I am writing to comment on the request for Amendment #4 to the site certificate for the Summit Ridge Wind Farm. Even though the construction deadlines for this project have already been extended twice, the developer (Pattern Development) now seeks yet another extension. I urge EFSC to deny Pattern's request to extend the deadlines a third time.

I am writing to comment on the request for Amendment #4 to the site certificate for the Summit Ridge Wind Farm.

HABITAT MITIGATION PLAN

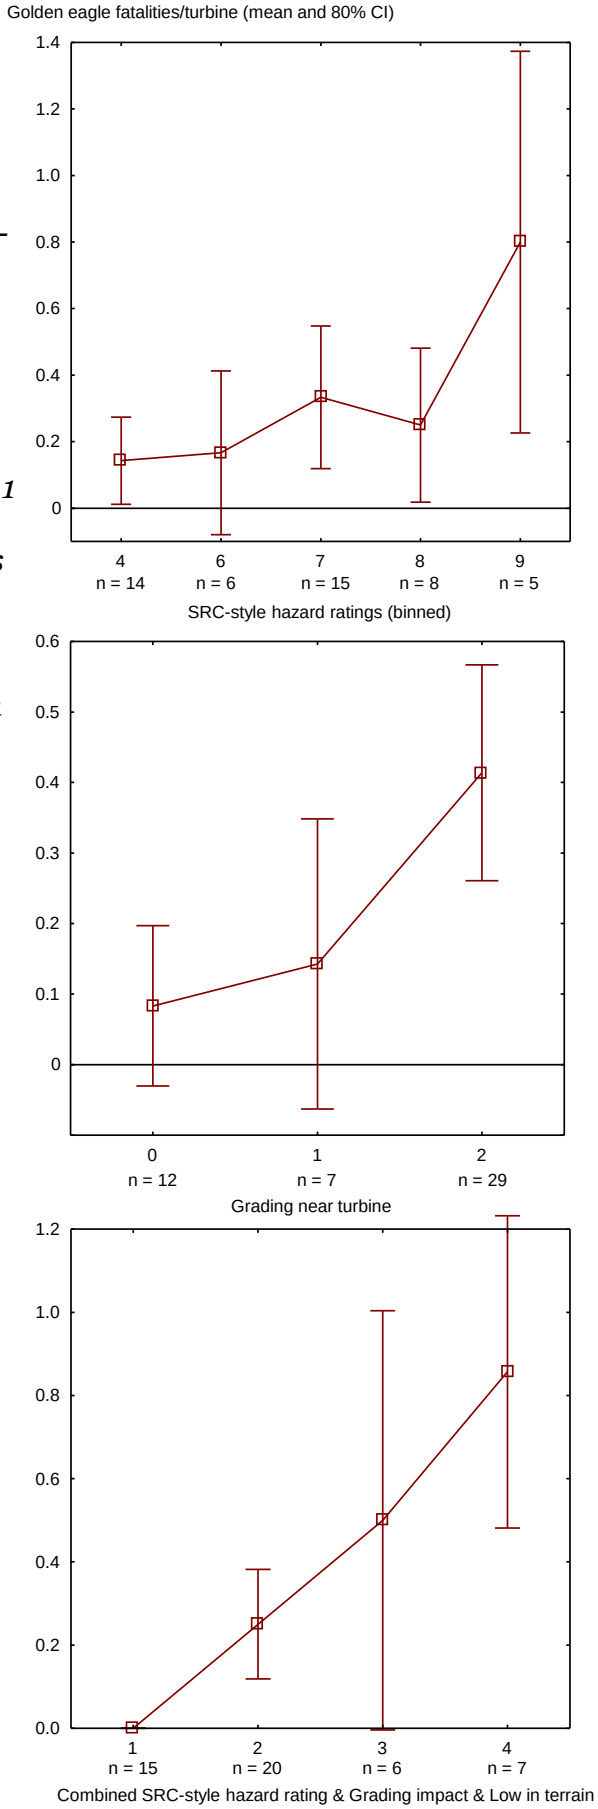
Based on the 14 golden eagle fatalities of which I am aware, fatalities per turbine generally increased at Golden Hills with my SRC-style hazard ratings (Figure 3). Wind turbines rated 9 or 9.5 were associated with a mean golden eagle fatality rate that was 5.7× higher than the mean fatality rate at wind turbines I had rated 4 or 5. Wind turbines rated in the 7 or 8 ranges were associated with mean fatality rates that were 1.8× and 2.4× higher than the mean fatality rate of wind turbines I had rated 4 or 5. However, some of my ratings were likely confounded by grading during construction.

Golden eagle fatalities per turbine were highest where grading left berms or cut slopes >3 m within 40 m of the turbine (Figure 3). At these turbines with substantial nearby berms or cut slopes, golden eagle fatalities per turbine numbered 5× higher than at turbines without berms or cut slopes. Berms and cut slopes reduce the effective height above ground that low-flying eagles have to negotiate between the ground and the low reach of the turbine rotor, and the effect increases the closer the distance between turbine tower and the berm or cut slope.

Combining my SRC-style ratings, level of grading, and whether the turbine address was low on a declining ridge or slope or within a ridge saddle, golden eagle fatalities among 7 wind turbines averaged 0.857 per turbine (0.5 fatalities/MW), whereas 0 fatalities were found at wind turbines located high on ridge or hill structures, lacking berms or cut slopes, and for which I rated low to moderate hazard (Figure 3). Mean fatality rates increased linearly with this indicator integrating multiple factors (Figure 3).

Figure 3 indicates that the process used to derive collision hazard models was fruitful for understanding factors related to golden eagle collisions with wind turbines. The hazard maps were derived from study of hundreds of golden eagle fatalities among old-generation wind turbines located on a landscape that was digitized and measured for dozens of terrain attributes. They were derived from hundreds of hours of behavior surveys, the data from which were also related to terrain attributes. Though not ready for use at the time of micro-siting at Golden Hills, later hazard maps were additionally derived from tens of thousands of GPS telemetry of nearly 30 golden eagles. From all of these data, and from observing the outcomes of repowering at Diablo Winds, Buena Vista, Vasco Winds and Golden Hills, I have learned that extreme grading for access roads and turbine pads can interfere with collision hazard model predictions by adding significant risk to turbine sites. I have also learned that turbines located low on ridge structures or within ridge saddles can be hazardous, even if the turbines are modern and large. These low-lying turbine sites are generally also where grading tends to be more extreme, exacerbating the hazard at these sites. My SRC-style hazard ratings anticipated most of this risk, but turbine sites 3 and 15 at Golden Hills exemplify sites where my ratings were too conservative.

Figure 4. *Logit regression model predictions of the probability of Golden Hills wind turbines causing a golden eagle fatality.*

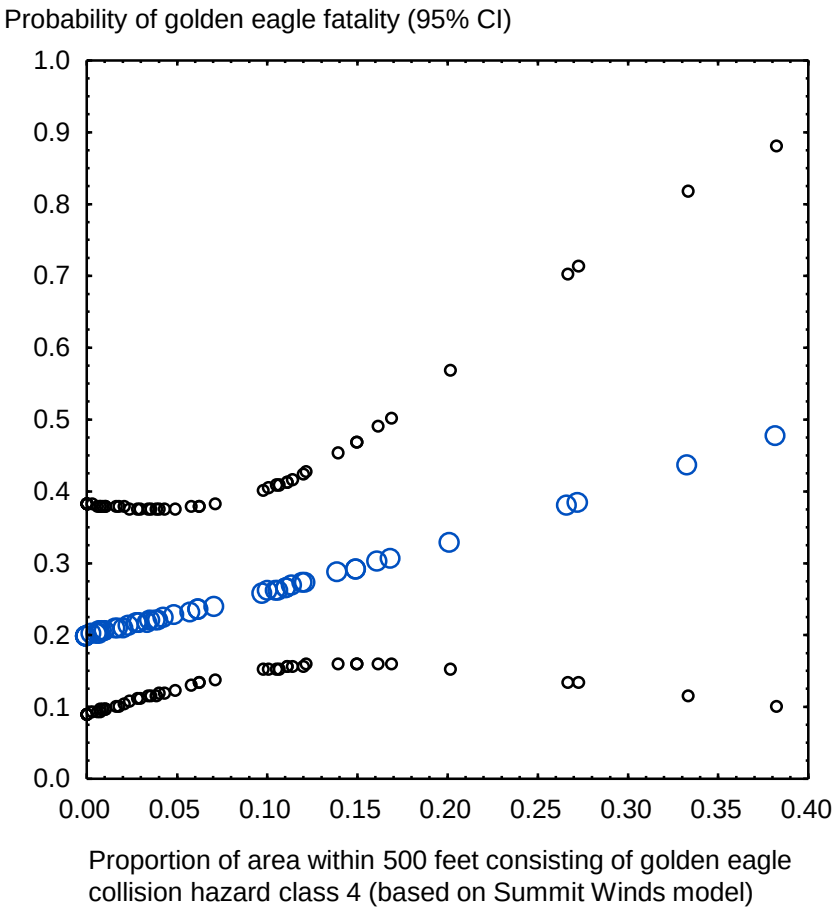
where $\hat{F}$ represents the predicted fatality outcome, and H4 represents collision hazard class 4 as a proportion of a 500-foot count radius (Figure 4). According to the Summit Winds model predictions, Golden Hills turbines with 39% of the surrounding area consisting of hazard class 4 were 2.4× more likely to kill golden eagles than turbines with no class 4 within 500 feet. The confidence intervals widen with increasing area in hazard class 4, however, probably due to confounding influence of grading. Even with these increasing confidence intervals, the prediction accuracy of the latest collision hazard model looks good, though still not as good as the expertise developed from iteratively checking field experience against collision hazard models.
